PUBLIC NOTICE

**New York District
Permit Application No..
NAN-2020-00835-M7**

PROPOSED MODIFICATION: The permittees have requested a permit modification for the following:

PILE REMOVAL AND GROUND STABILIZATION AT PIER 68

FIGURE 9
LOCATION OF COFFERDAM EXTENSION
Gateway Development Commission
Hudson River, New York, NY

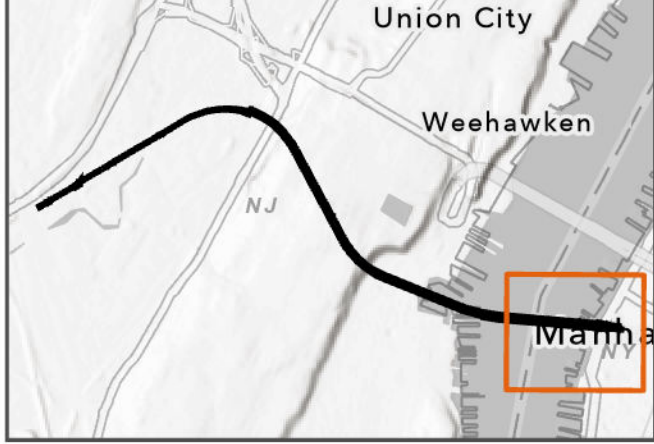
Extend the temporary cofferdam eastward by approximately 265 linear feet toward the Manhattan shoreline to better facilitate the removal of existing piles (approximately 500 piles) and obstructions within the footprint of the former Pier 68. Approximately 5,398 cubic yards of material would be dredged to a depth of five feet below the existing grade of the river. Ground stabilization activities would be conducted within the limits of the extended cofferdam.

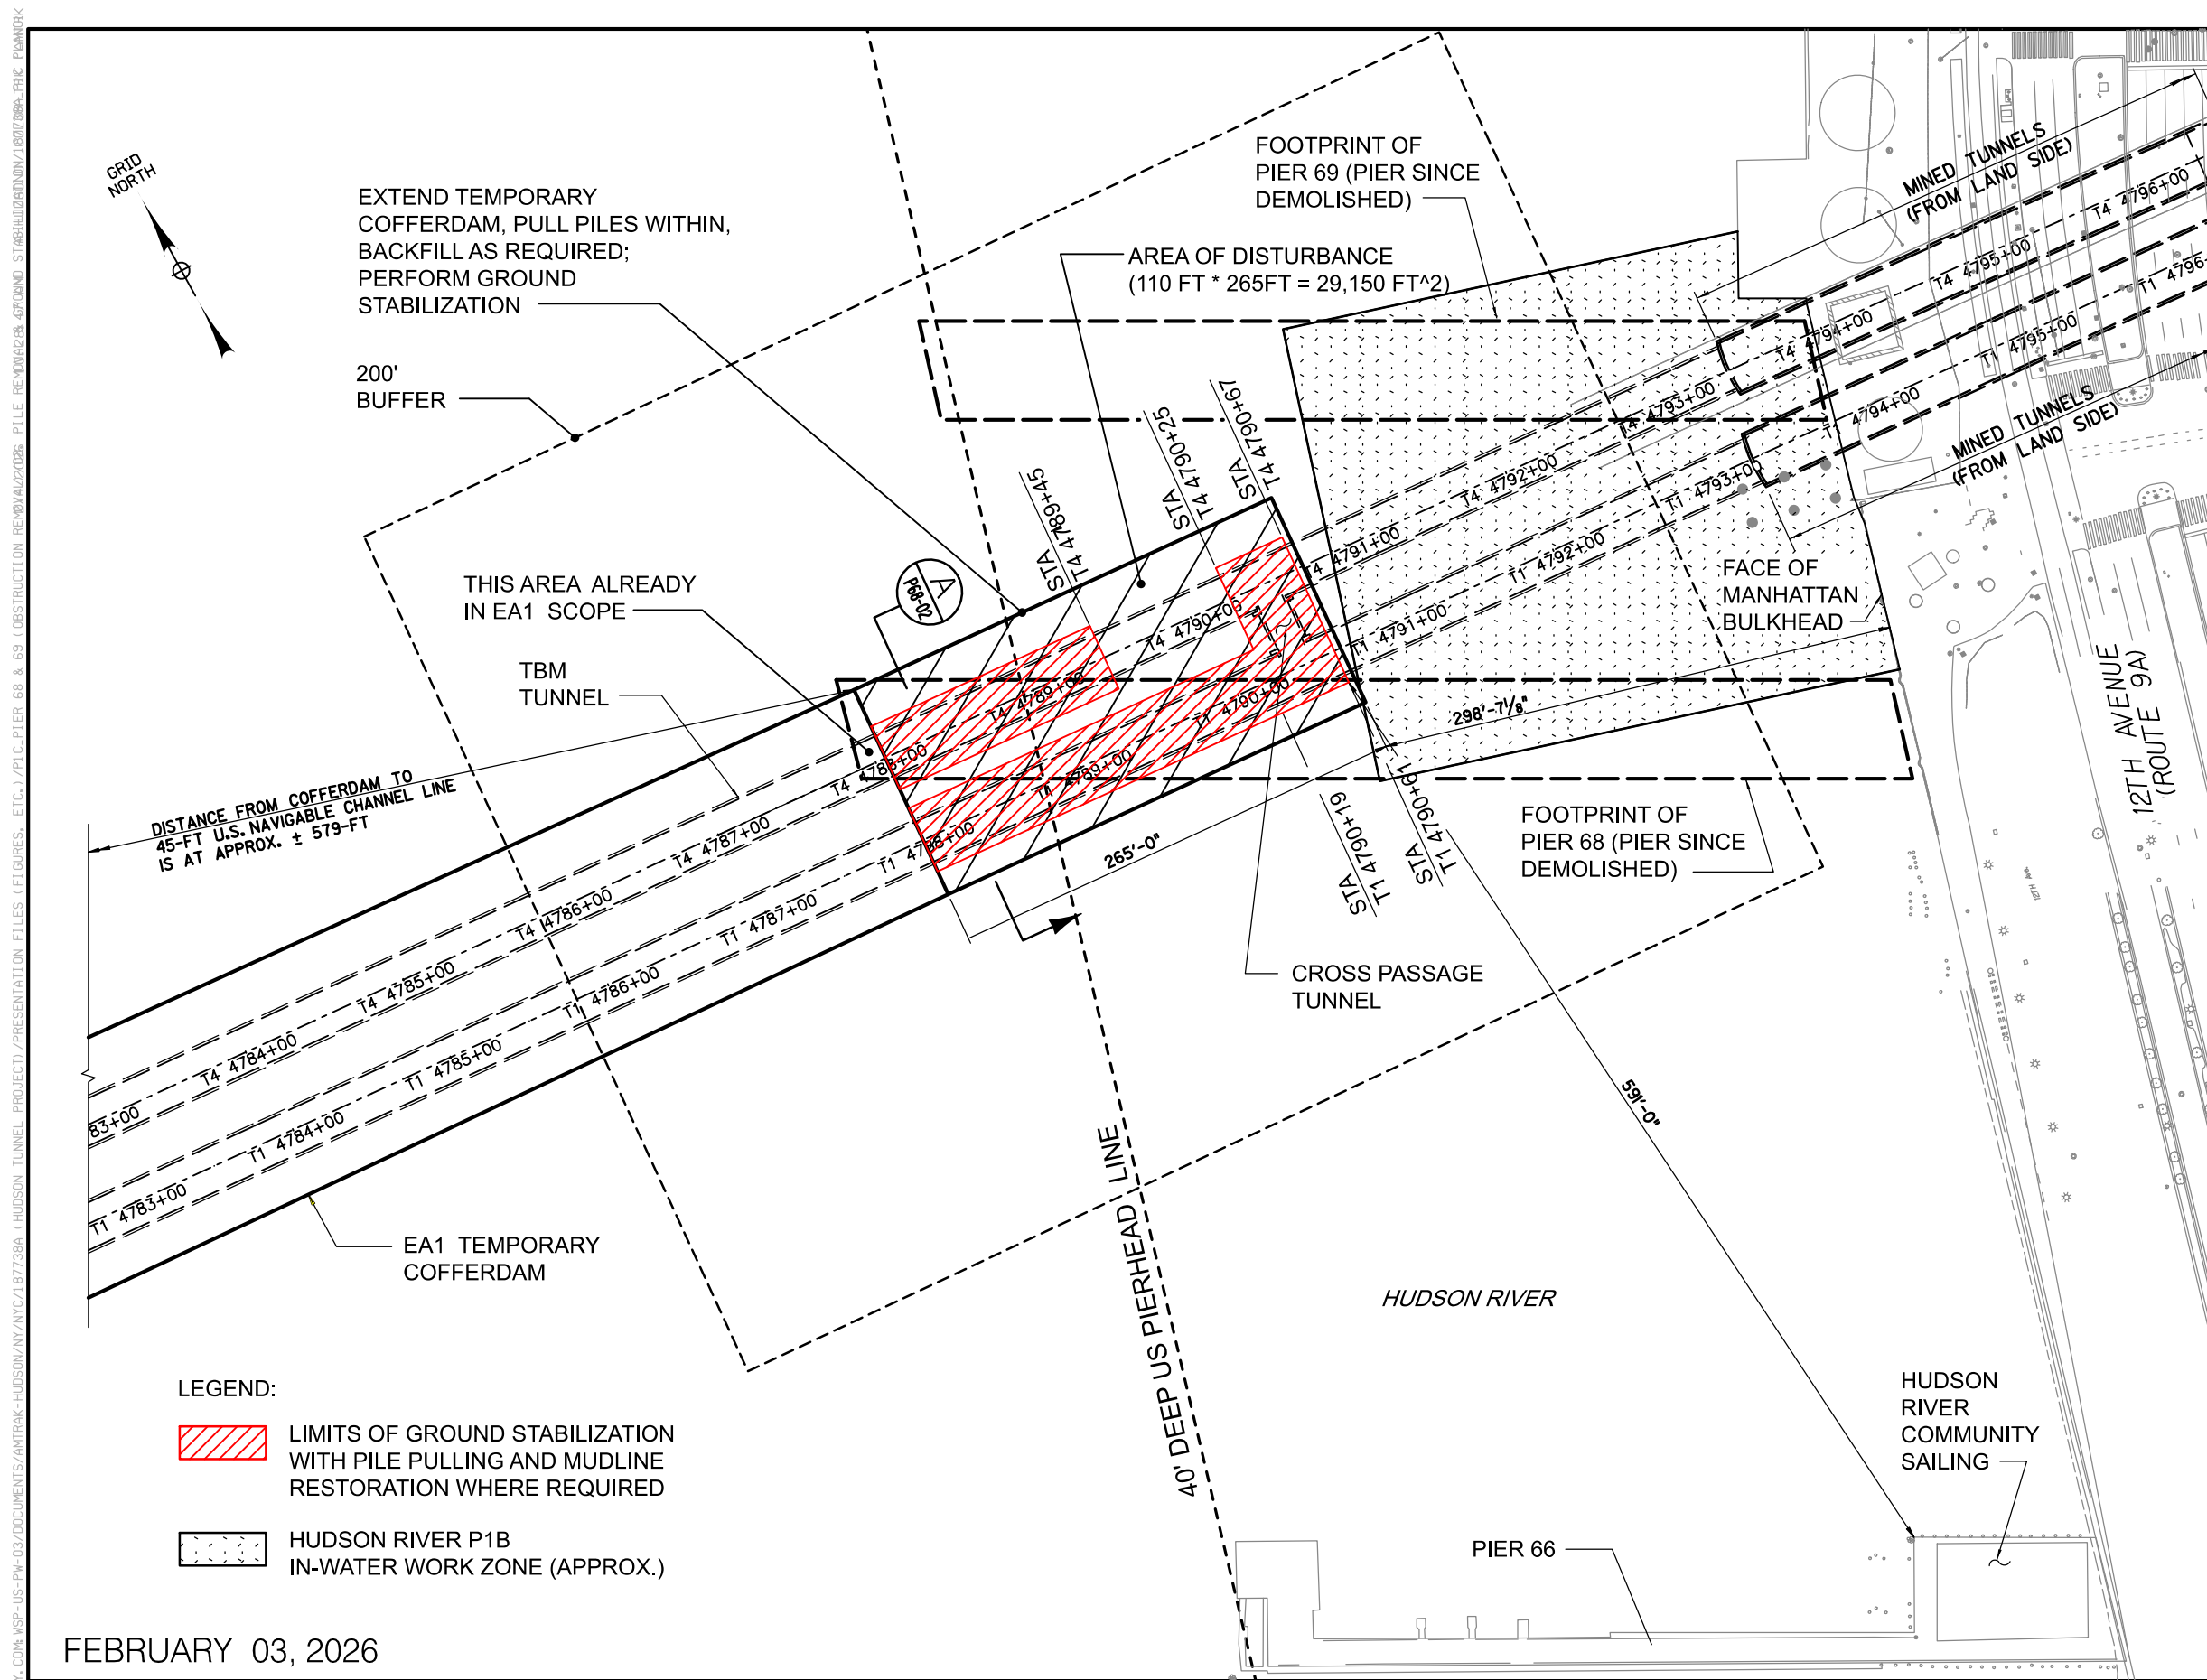
- NOTES:
1. PULL PILES WITHIN FOOTPRINT OF FORMER PIER 68.
 2. AFTER PILE PULLING, RESTORE MUDLINE IN ACCORDANCE WITH 2024 BATHYMETRY WITH SAND, CONFORMING WITH ASTM C33 WITH MAXIMUM 5% FINES (PASSING NO. 200 SIEVE) BY MASS. ALL SAND MATERIALS USED TO RESTORE 2024 MUDLINE SHALL HAVE A LOOSE DRY UNIT WEIGHT BETWEEN 95 AND 100 POUNDS-PER-CUBIC-FOOT (PCF). PRIOR TO PLACEMENT, SUBMIT SAND MATERIAL GRADATION AND DENSITY TESTING RESULTS FOR REVIEW AND ACCEPTANCE BY THE COMMISSION.

3. PERFORM GROUND STABILIZATION IN ACCORDANCE WITH THE CURRENT PACKAGE EA1 SPECIFICATION SECTION 31 32 13 (GROUND STABILIZATION) REQUIREMENTS, WITH THE FOLLOWING NOTED EXCEPTIONS: (1) AN ADDITIONAL FIELD DEMONSTRATION TESTING PROGRAM, AS REQUIRED BY SECTION 31 32 13, PART 3.3.B.2, SHALL NOT BE REQUIRED; (2) UNIFORMITY EVALUATIONS, AS REQUIRED BY SECTION 31 32 13, PART 3.8.G.3, SHALL BE AT LEAST 75 PERCENT TREATMENT (CORE RECOVERY) IN LIEU OF THE CURRENT SECTION 31 32 13, PART 3.8.G.3 90 PERCENT REQUIREMENT; AND (3) PERFORM AT LEAST ONE (1) FULL DEPTH QA/QC CORE FOR EVERY 2,000-SQUARE-FEET OF JET GROUT TREATED AREA IN LIEU OF THE CURRENT SECTION 31 32 13, PART 3.8.E.7 ONE (1) CORE FOR EVERY 800-SQUARE-FOOT OF TREATMENT REQUIREMENT. ALL OTHER SECTION 31 32 13 (GROUND STABILIZATION) REQUIREMENTS SHALL REMAIN IN FORCE AND APPLICABLE TO THESE ADDITIONAL JET GROUTING OPERATIONS.

4. DEEP SOIL MIXING SHALL NOT BE USED (DUE TO POTENTIALLY REMAINING PILES). PERFORM GROUND STABILIZATION UTILIZING JET GROUTING METHODS AND TECHNIQUES.

5. PRIOR TO COMMENCING WORK, PREPARE AND SUBMIT A CONSTRUCTION WORK PLAN FOR ALL PILE PULLING, MUDLINE RESTORATION, AND GROUND STABILIZATION ACTIVITIES, WITHIN THE EXTENDED TEMPORARY COFFERDAM LIMITS, FOR REVIEW AND ACCEPTANCE BY THE COMMISSION.

HUDSON TUNNEL PROJECT
PILE REMOVAL AND GROUND STABILIZATION AT PIER 68
SECTION AND PROFILE

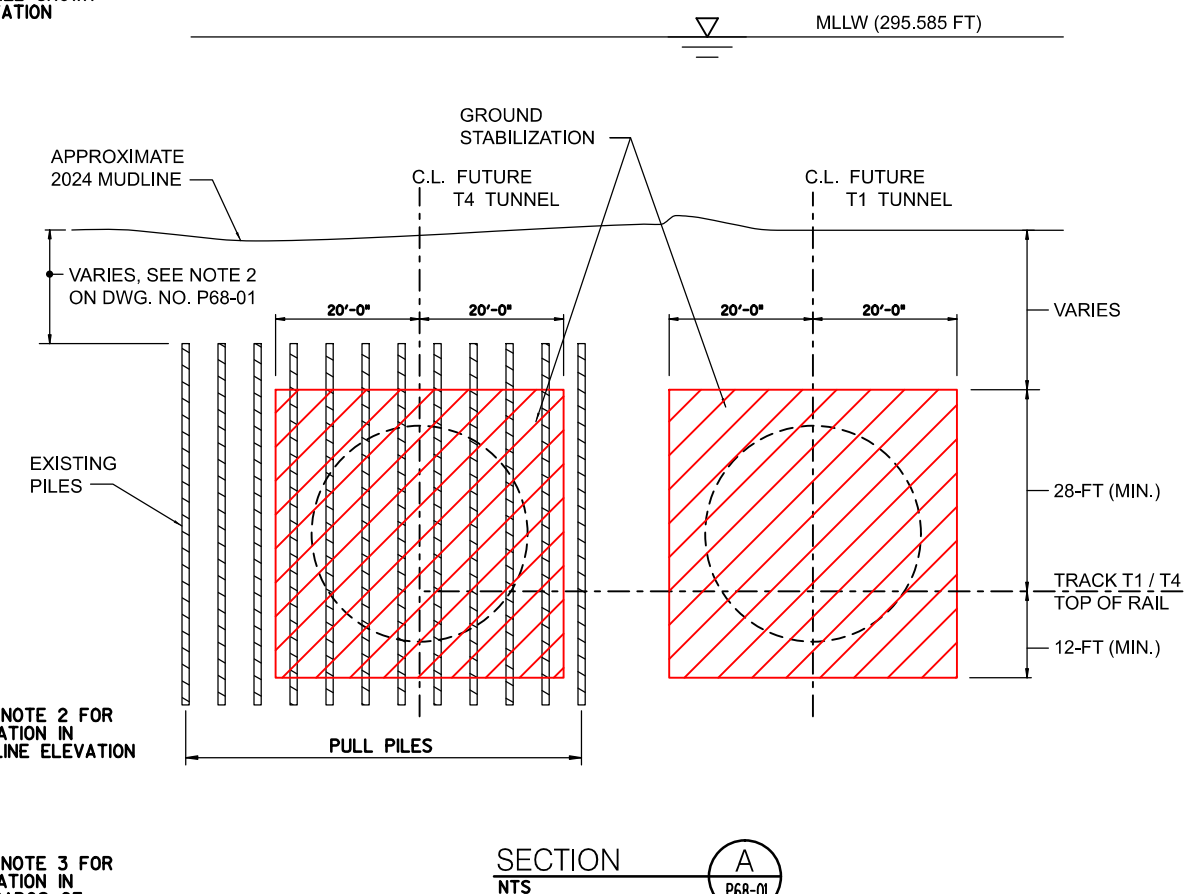
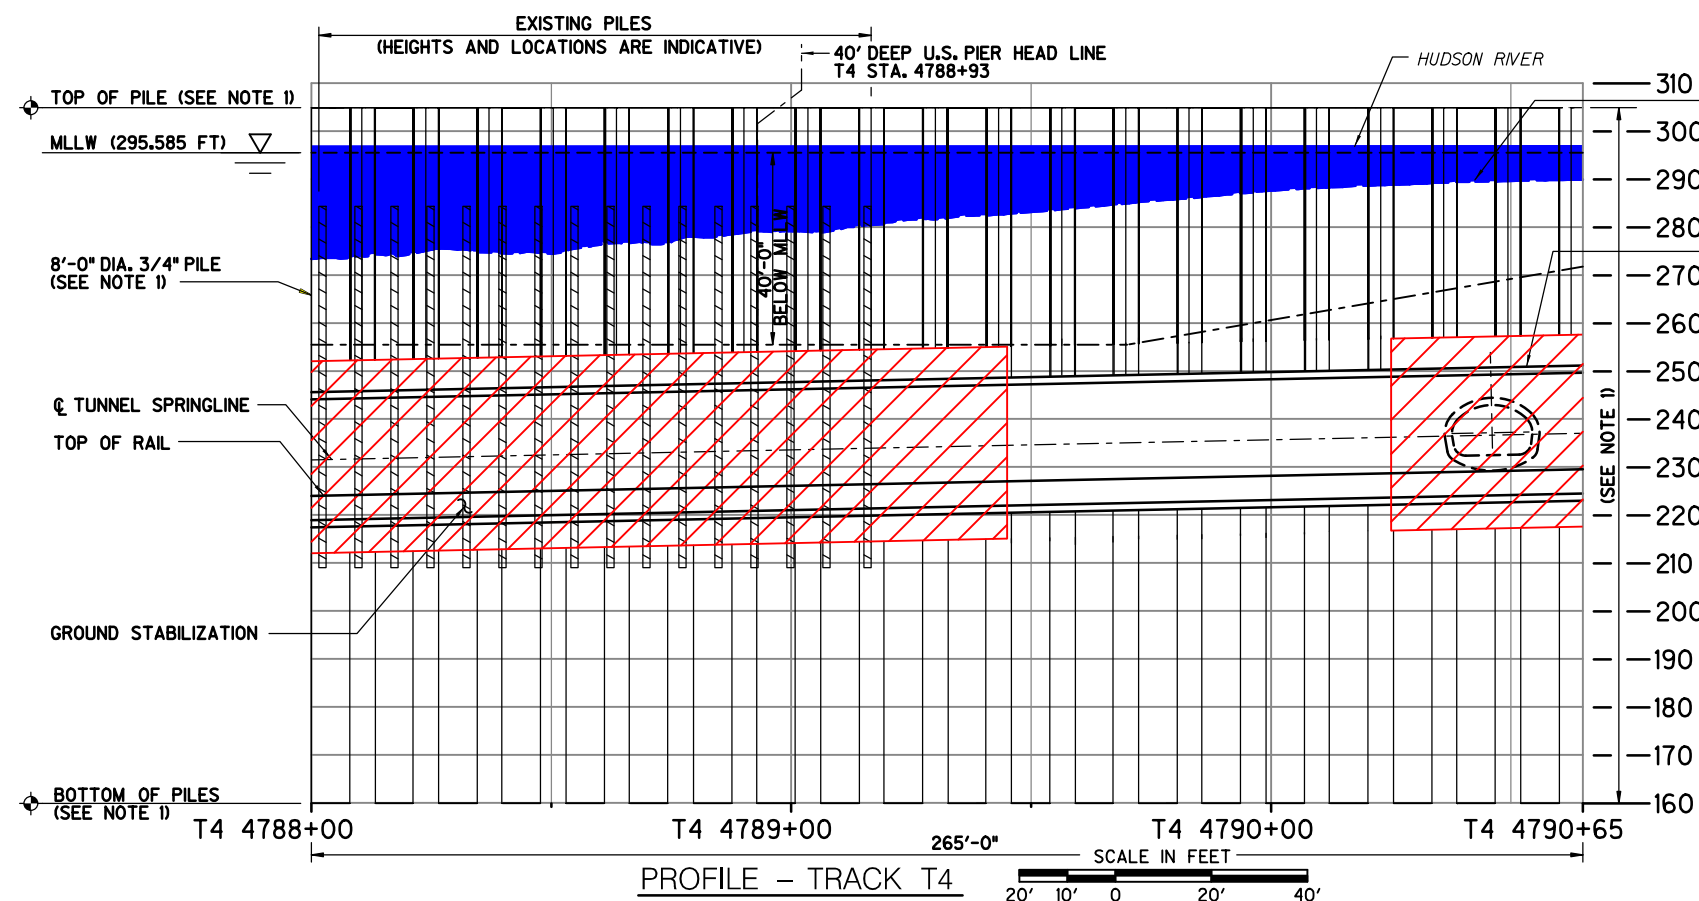
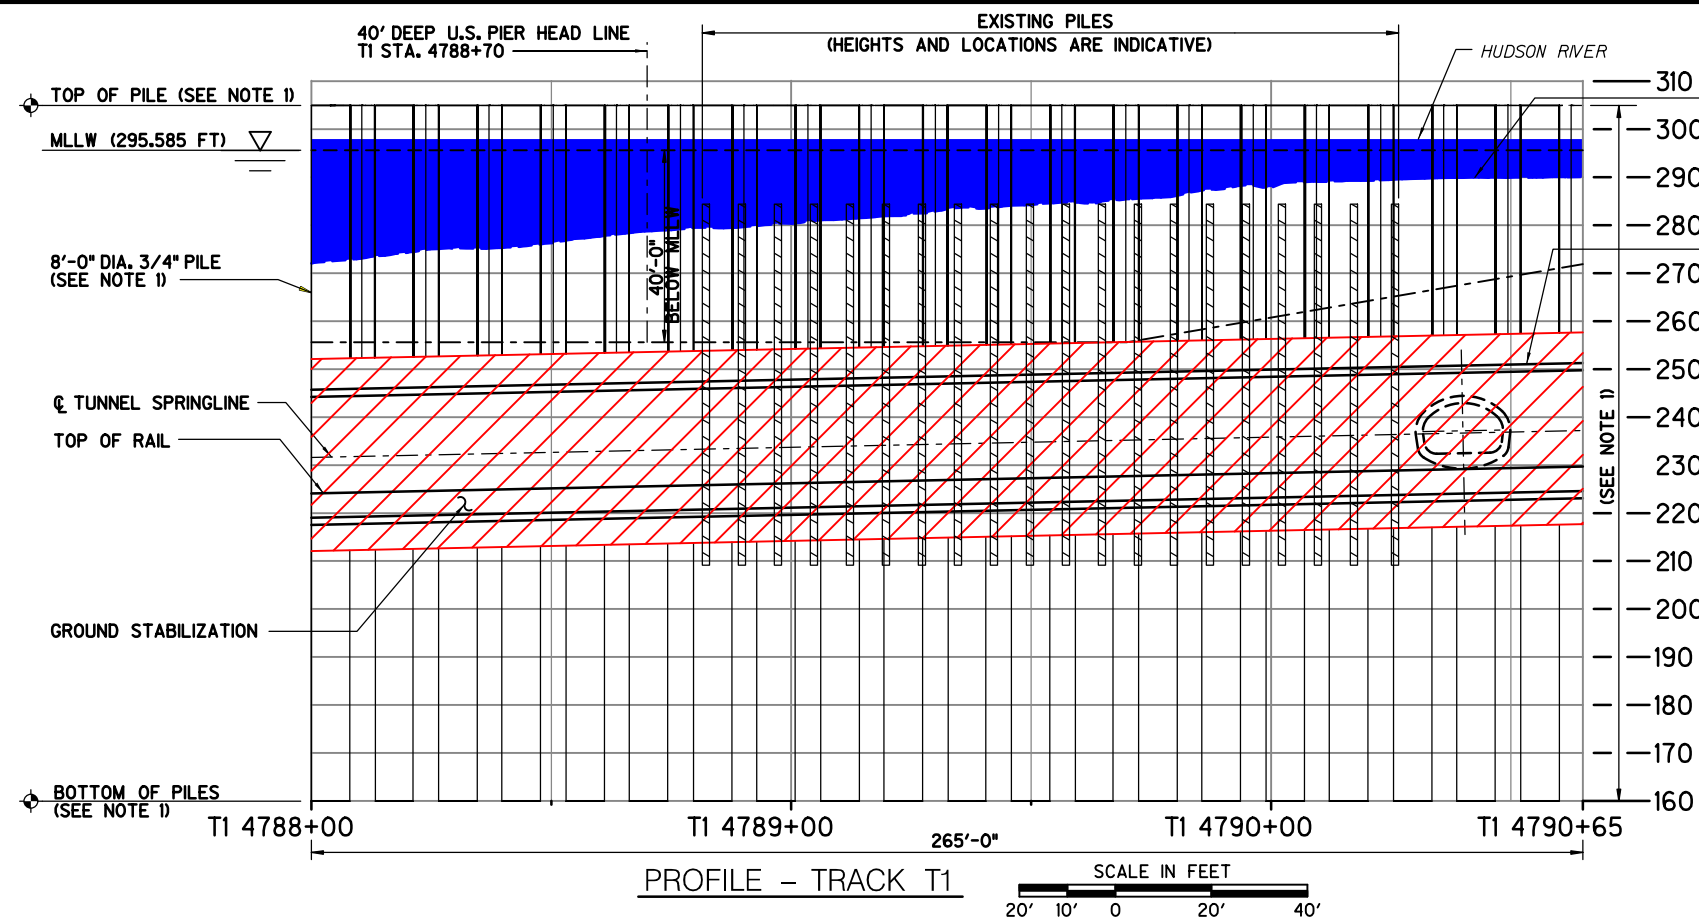
1. THE COFFERDAM PILE DEPTHS AND DETAILS SHOWN IN THIS DRAWING ARE INDICATIVE.
2. MUDLINE ELEVATION VARIES FROM APPROXIMATELY 272 TO 290 FEET ALONG T1 AND FROM 274 TO 290 FEET ALONG T4 BETWEEN STA. 4788+00 AND STA. 4790+65.
3. EXTRADOS OF TUNNEL CROWN ELEVATION RANGES FROM APPROXIMATELY 246 TO 251 FEET ALONG T1 AND T4 BETWEEN STA. 4788+00 AND STA. 4790+65.
4. GROUND STABILIZATION SHALL EXTEND FROM A MINIMUM OF 12 FEET BELOW THE TOP OF RAIL ELEVATION (APPROXIMATELY 212 TO 218 FEET) TO A MINIMUM OF 28 FEET ABOVE THE TOP OF RAIL ELEVATION (APPROXIMATELY 252 TO 258 FEET) ALONG TRACKS T1 AND T4 BETWEEN STA. 4788+00 AND STA. 4790+65.
